EGG-SSDC-5288

HUMAN FACTORS ENGINEERING EVALUATION OF  
THE ADVANCED TEST REACTOR CONTROL ROOM

M. P. Boone  
W. W. Banks

Figure 27. Nonfunctional ion chamber insert-withdraw switch.

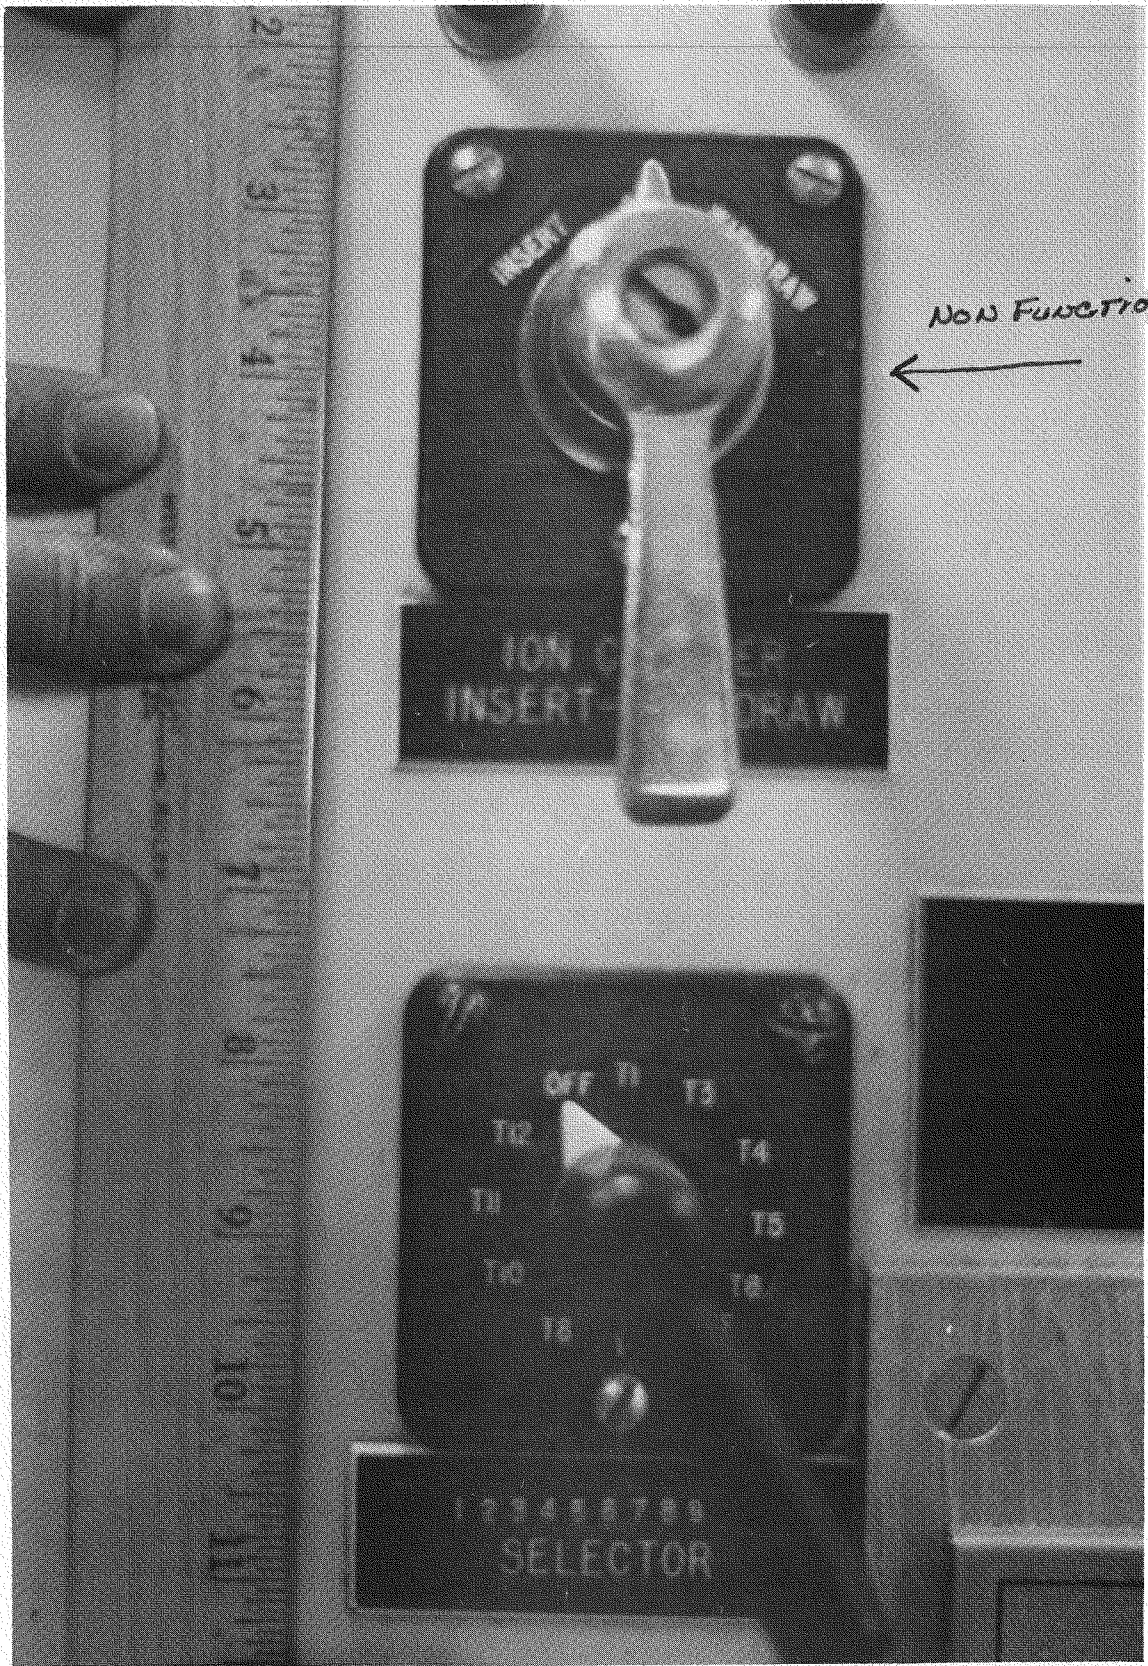
The CRT display keyboard (Figure 26), and ion chamber insert/withdraw switch (Figure 27), were found to be electrically disconnected and non-functional. It is recommended that all nonfunctional or unused components be physically removed from the console. This will reduce visual noise, visual search time, conserve priority space, and improve operator performance in high workload or emergency situations.

Figure 29. Anion regeneration system. (The indicator lights show circuit activation; not valve opening.)

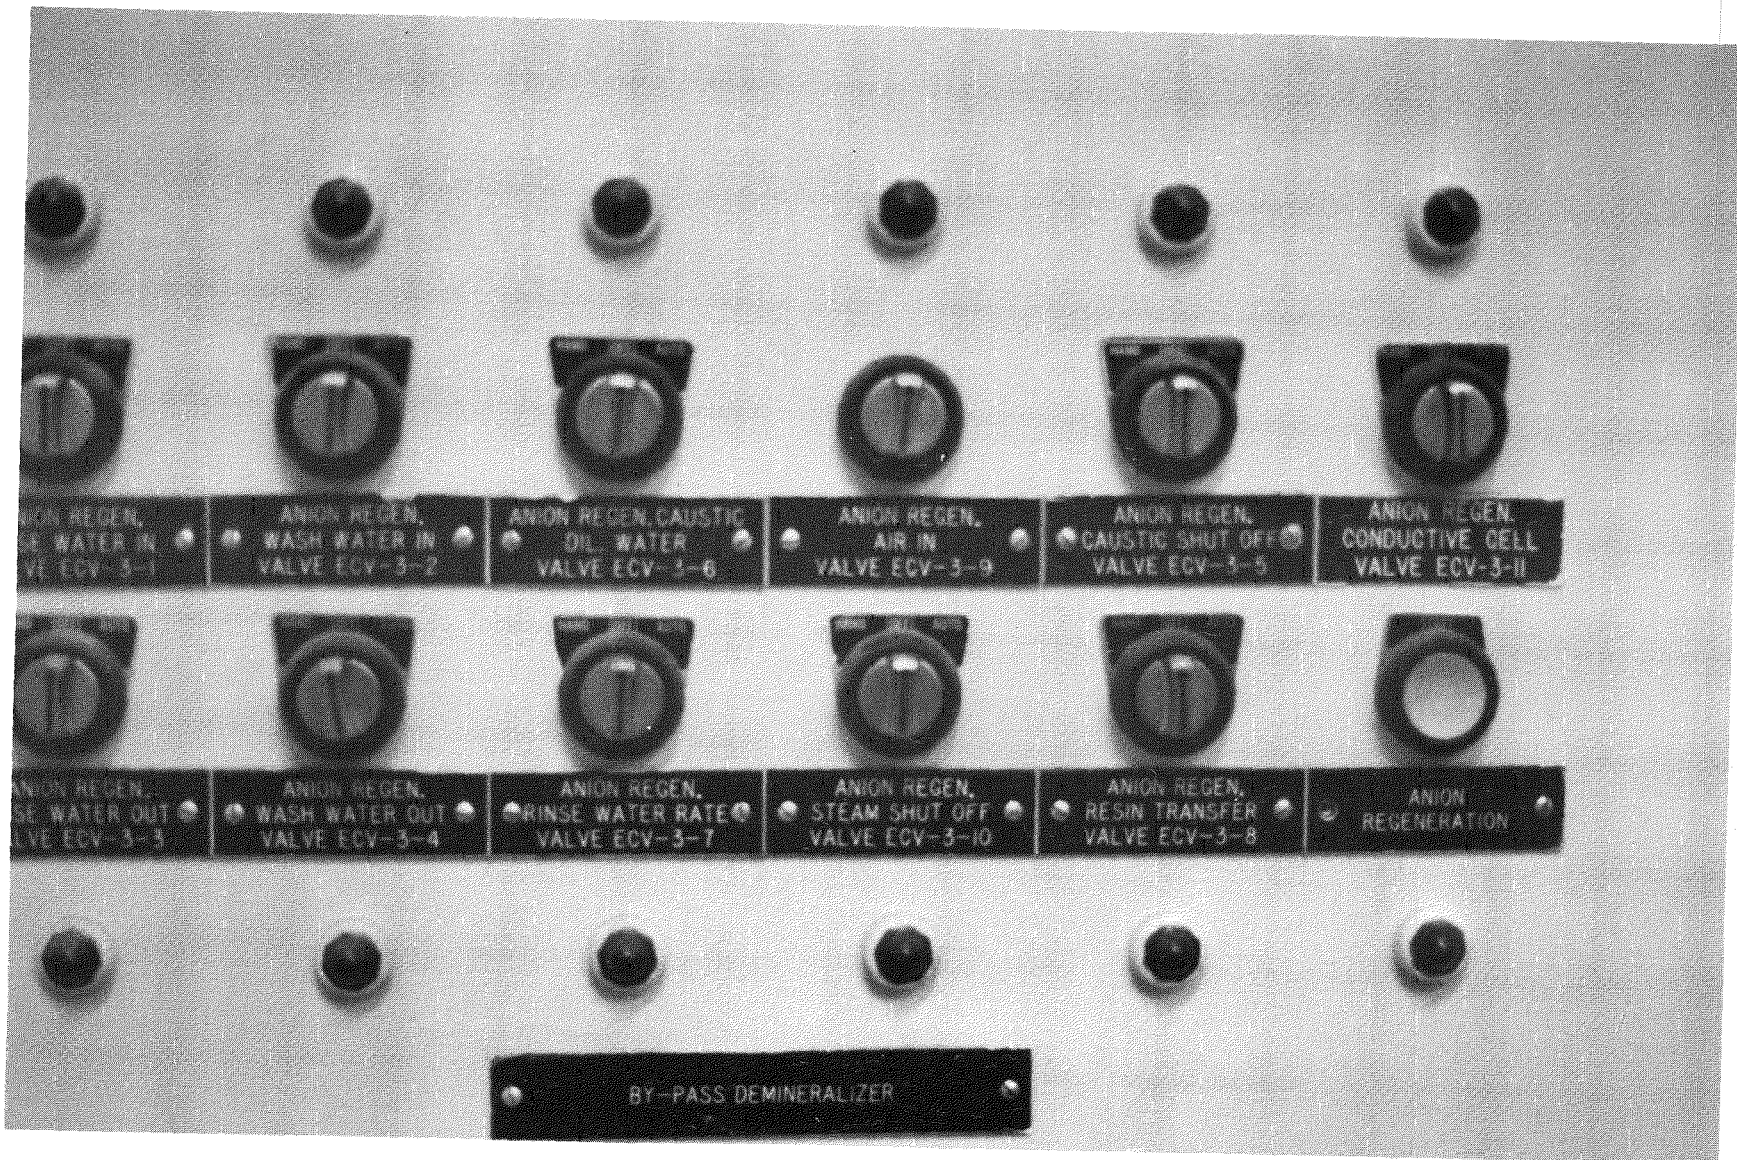
There is no feedback to the operator regarding physical opening of valves used during primary anion regeneration. When the anion regeneration cycle is initiated, a light indicates the regeneration cycle has started. The light does not inform the operator that the valves necessary for the operator are actually opened but only that the control has been activated. We recommend that valves be directly instrumented to give accurate feedback concerning their position (see Figure 29).

Figure 30. Conversion chart necessary to interpret meter indications.

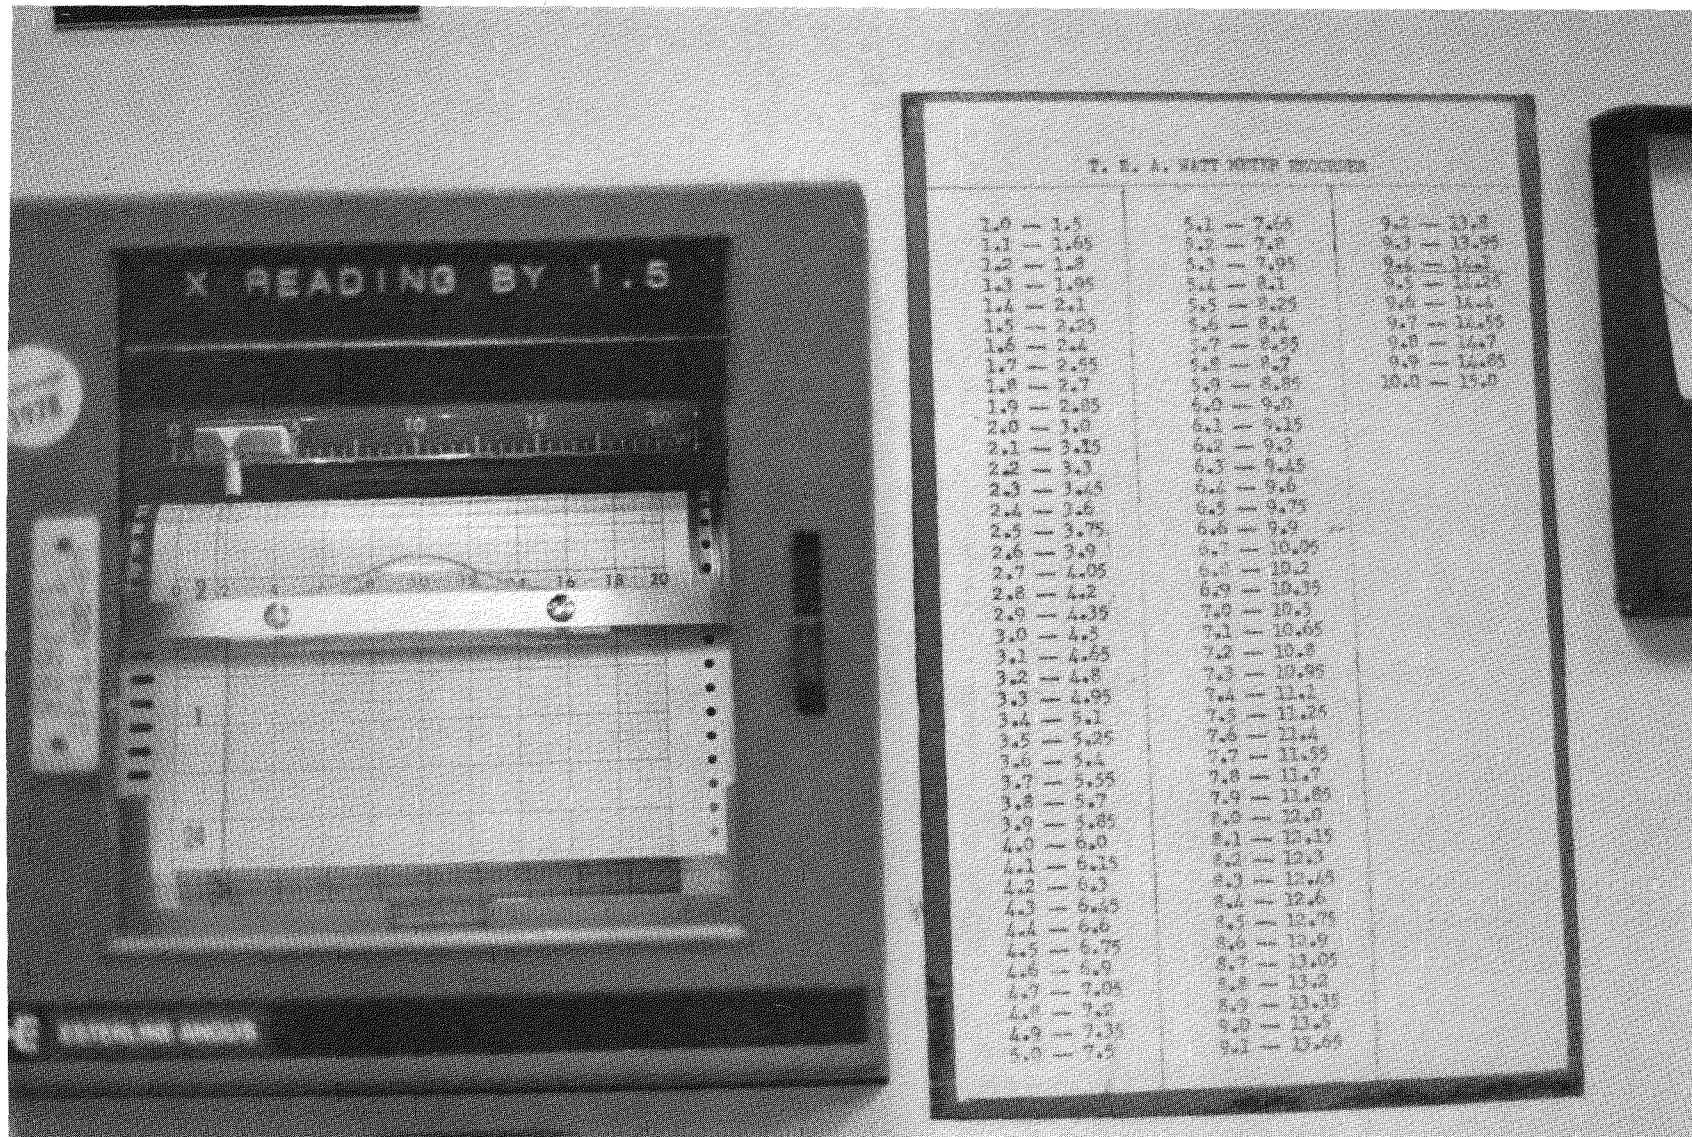
The degassing tank drain flow indicator, secondary makeup and blowdown valve, and watt power meter do not provide operators with conversion-free

data. Operators must first read the data and then use a conversion chart before they can interpret what the information means and take appropriate action (PR-1-16). We recommend that indicators be provided that do not require conversion charts and give the desired information directly (see Figure 30 for illustration of watt power indications).

Figure 31. Pump bearing temperature indicators.

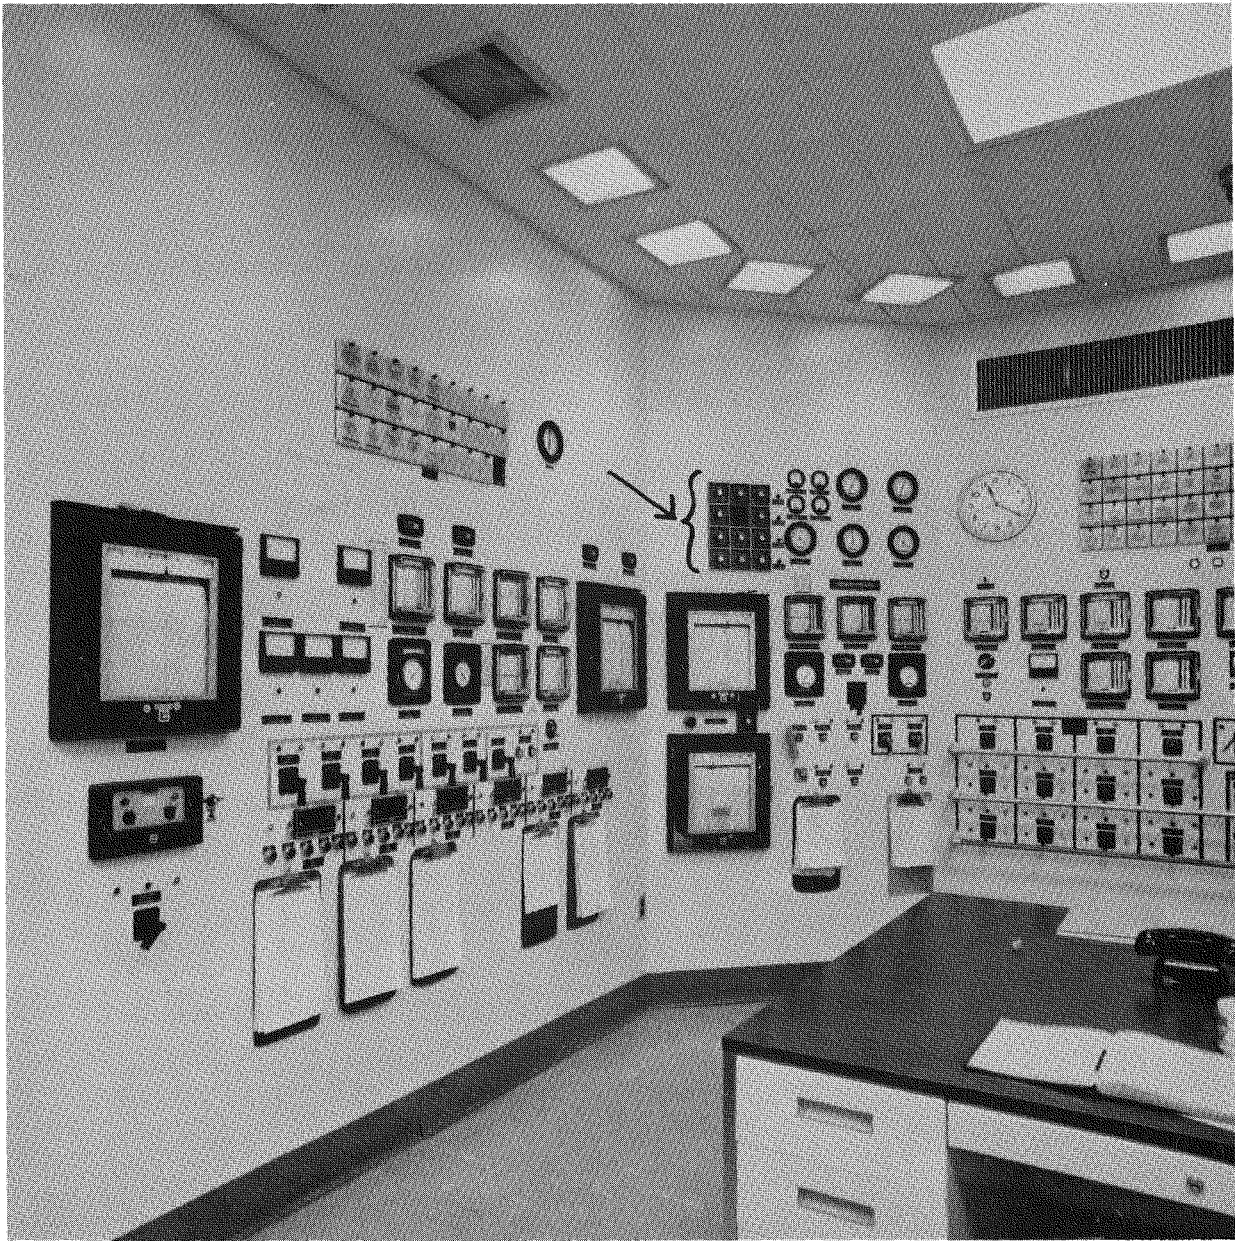
During the course of our evaluation, it was learned that the bearing temperature displays require finger tapping by the operators in order to obtain accurate readings. Needle pointers were said to jump between 1/16 and 1/8 in. after tapping. We recommend that the bearing temperature indicators be replaced with instruments that have higher reliability and of a design that does not require finger tapping (see Figure 31). Digital readouts may satisfy these criteria, and can be used where relative scale, position, and/or trend information is not essential.

Figure 32. Acid level indicator. (The tank is actually full when the meter reads 72%.)

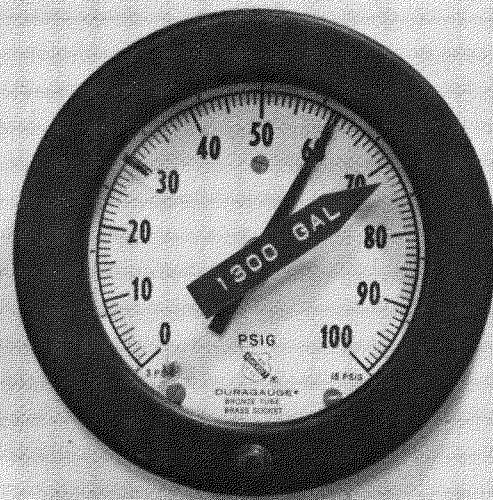
The scales on the acid-level indicator do not accurately indicate the true level of the acid tank. The reading is given in percent; however, when the meter reads approximately 75%, the tank is actually full (100%). Operators have attempted to compensate for the meter error by placing a piece of sticky tape on the meter glass (see Figure 32). The tape reads "1300 gal" and is placed on the meter glass at approximately the 72% mark (when the acid tank is actually full). The tape obscures the meter numbers and dial indicator. We recommend the meter or instrumentation be adjusted so that the meter reads correctly and the tape be removed.

Figure 33. Primary pump suction pressure, primary coolant pump pressure, hot waste and warm waste meters. (There is a parallax problem in reading each of these meters.)

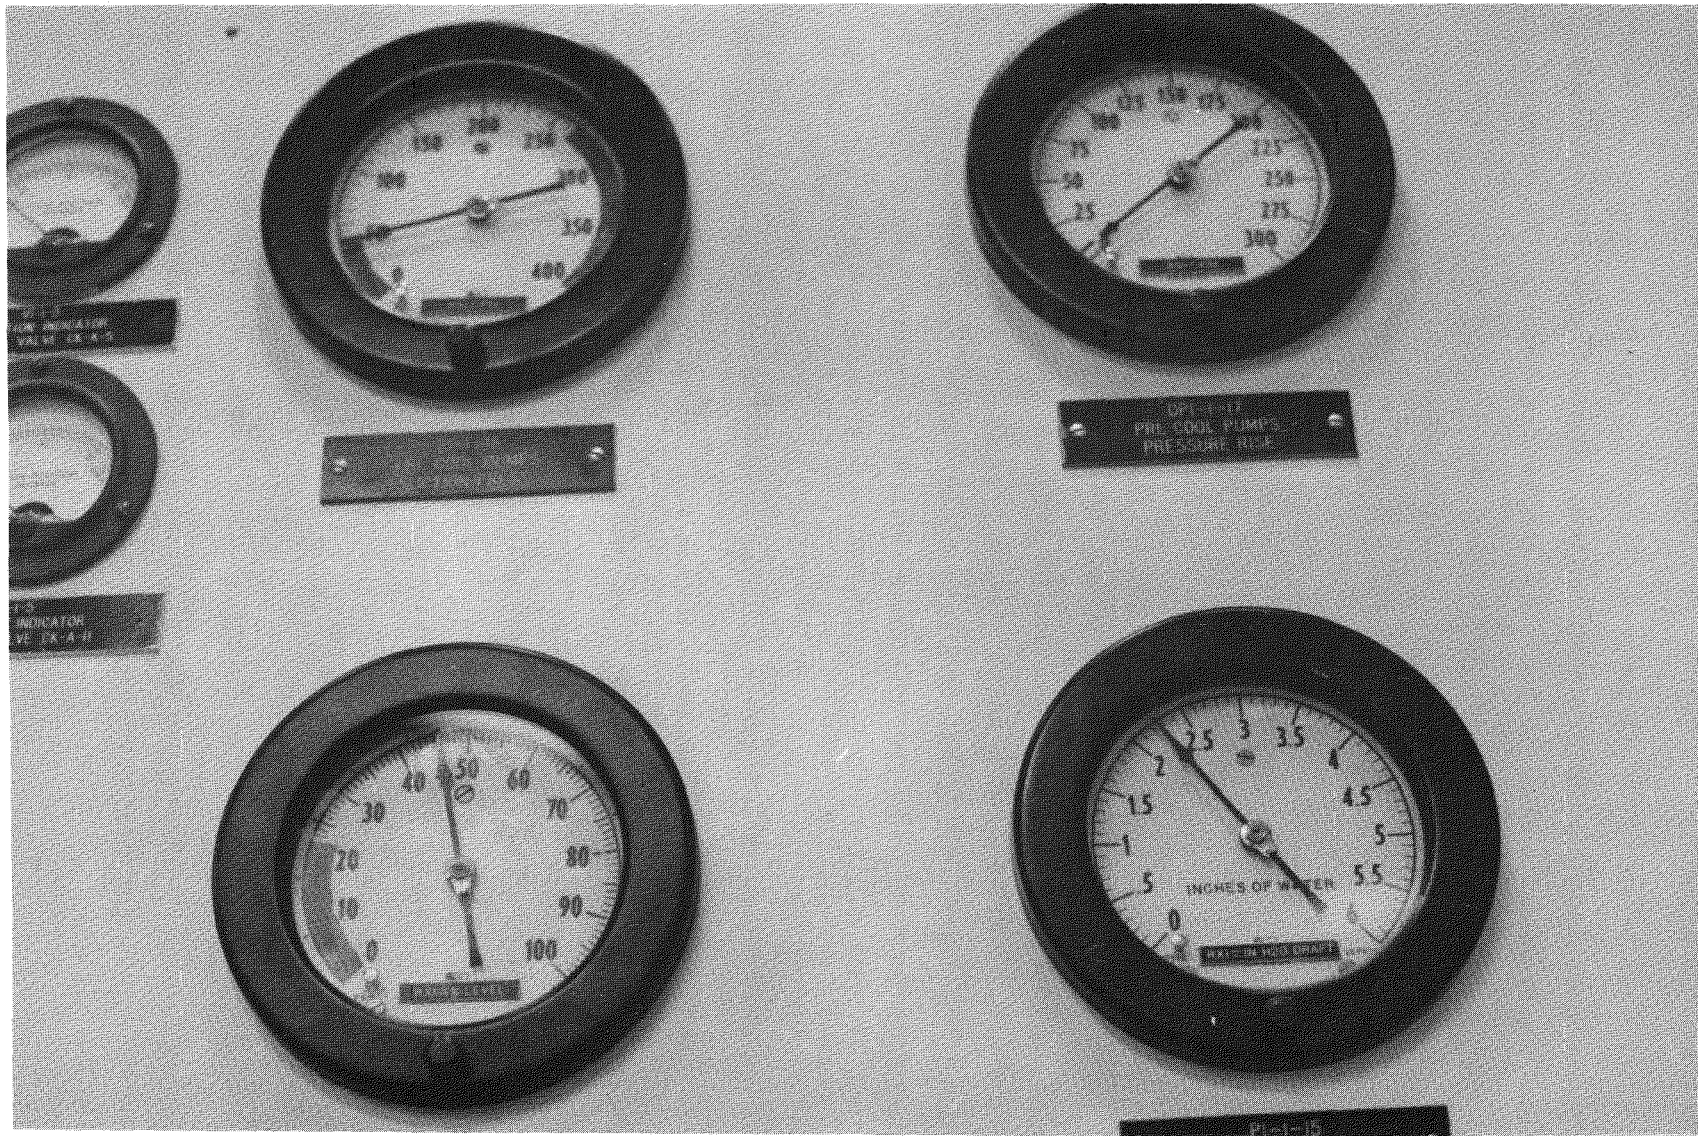
The primary pump suction pressure, primary coolant pump pressure, hot waste, warm waste, and acid-level meters are situated at a height greater than 6 ft 5 in. and are difficult to read primarily due to the viewing angle, although parallax is also present (see Figure 33). Since these meters are used quite frequently, it is recommended that they be either:
